**COMMITTEE OF THE WHOLE APRIL 18, 2005**

**ZONING BY-LAW AMENDMENT FILE Z.04.046  
DRAFT PLAN OF SUBDIVISION FILE 19T-03V10  
P. GABRIELE AND SONS LIMITED  
REPORT #P.2004.94**

# Draft Plan of Subdivision Red-Line Revised

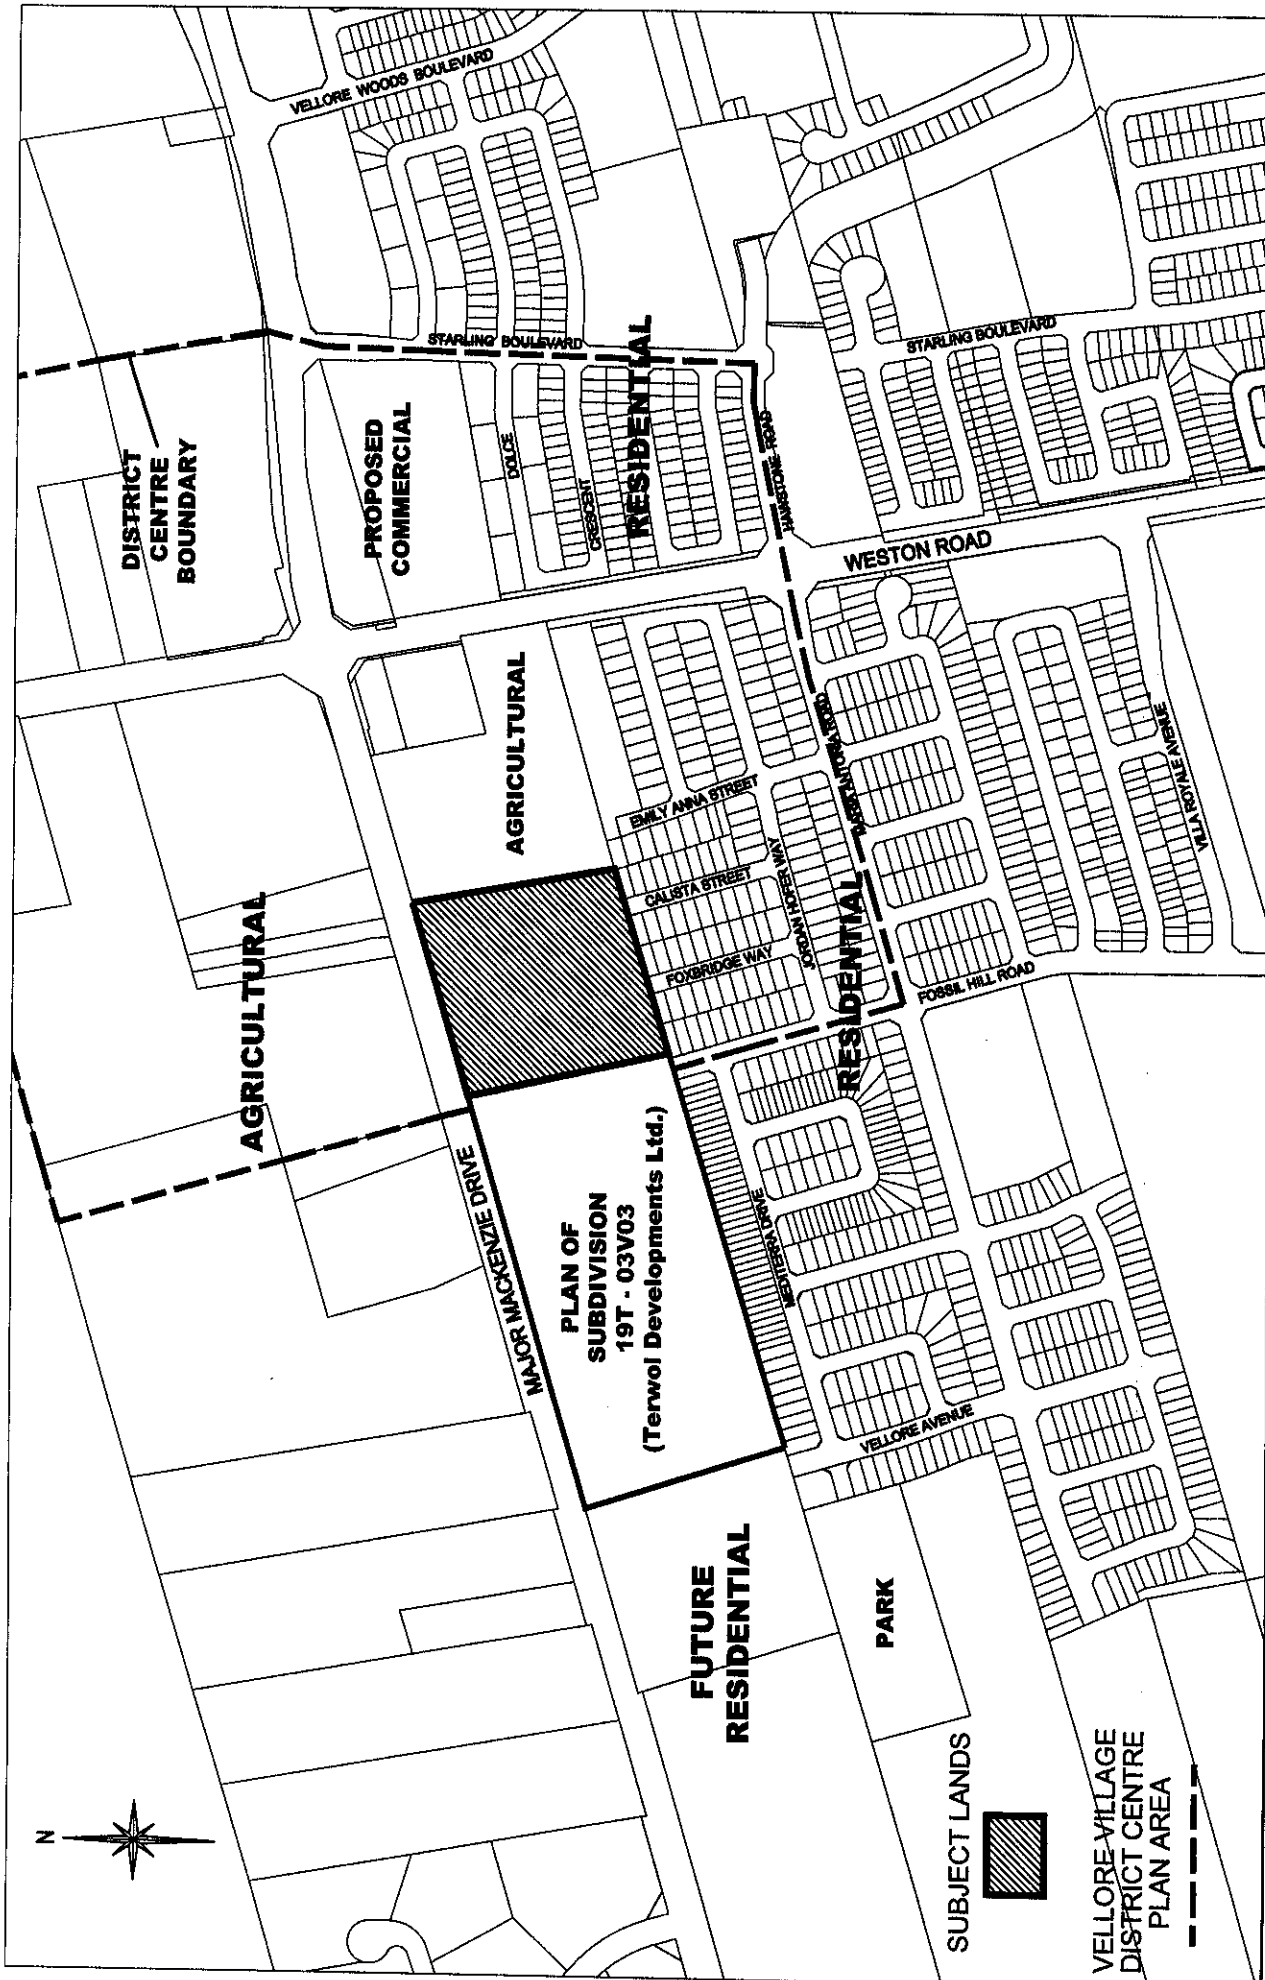
PROVIDE BLOCK TO FACILITATE COMMUNITY ENTRANCE FEATURE WALL

CITY OF VAUGHAN  
 RED-LINE REVISED  
 APRIL 18, 2005

Staff review has resulted in the draft plan of subdivision being red-lined, as shown on Attachment #3 to identify a separate Block to facilitate a future community entrance feature at the southeast corner of Major Mackenzie Drive and Forest Hill Road. Subject to the comments in this report, and the conditions of approval in Attachment #1, Staff is satisfied with the proposed subdivision design.

- a) incorporate a separate community entrance block at Major Mackenzie Drive and Fossil Hill Road intersection.
2. The lands within this Plan shall be appropriately zoned by a zoning by-law, which has come into effect in accordance with the provisions of the Planning Act. The zoning category to be applied is as follows:
